EVE IWG 69th session

HDV GTR Draft v15

General feedback in terms of feasibility

Extracts for Proposal for a new UN GTR on In-vehicle Battery Durability for Heavy Duty Electrified Vehicles

Method 2

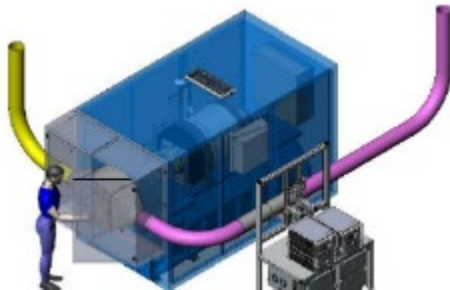
- specific vehicle test mode will be required, but has to be equal to driving operation window
- De-rating must be allowed in both directions
